## Product Change Notice (PCN)

PCN Number: **PCN-0451070R-02**

Product(s) Affected: **PJ-028-SMT-TR**

PREVIOUS CUI DEVICES DETAIL / IMAGE			NEW CUI DEVICES DETAIL / IMAGE

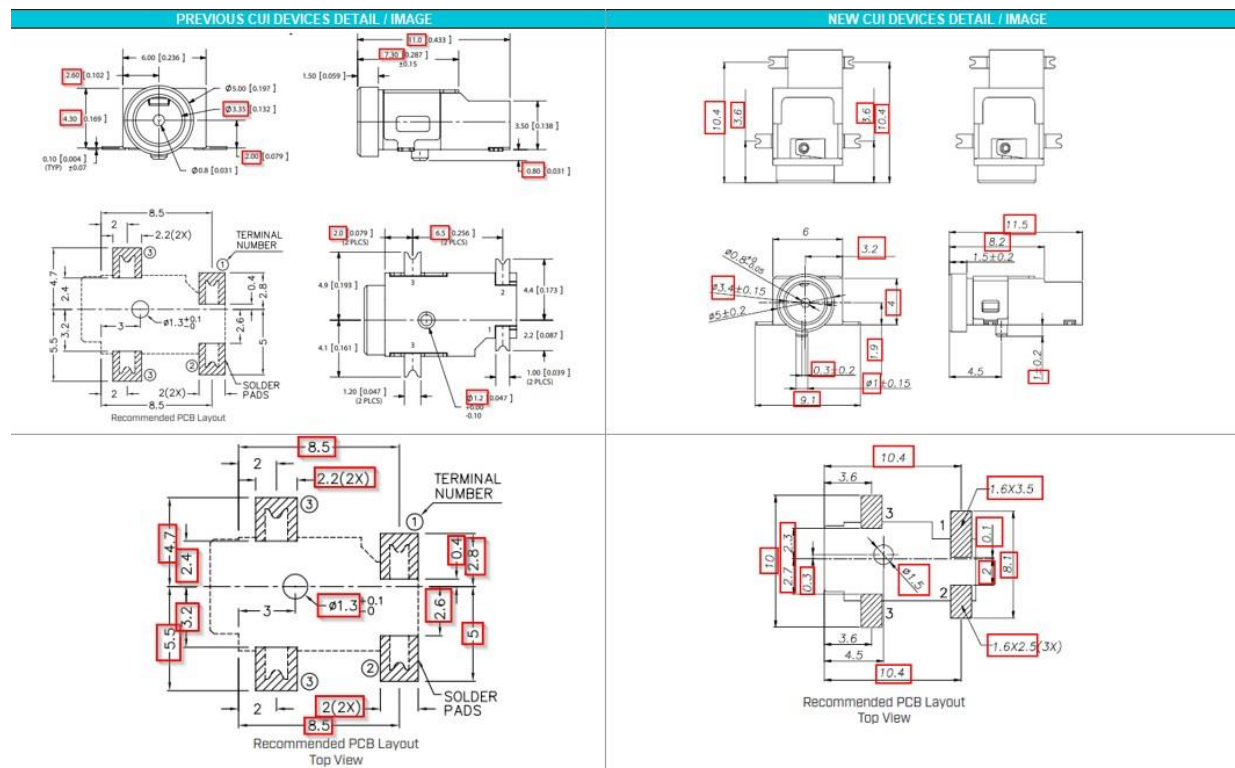
Description of Change: **Minor Housing and footprint differences. Material Change on the housing and terminals. See image Below**

MATERIAL	PLATING	DESCRIPTION	MATERIAL	PLATING/COLOR
center pin	brass	silver	center pin	brass	gold
terminal 1	brass	silver	terminal 1	brass t=0.20	gold
terminal 2	copper alloy	silver	terminal 2	phosphor bronze t=0.25	gold
terminal 3	copper alloy	silver	terminal 3	phosphor bronze t=0.20	gold
plastic	PA10T		housing	PA9T (UL94V-0)	black
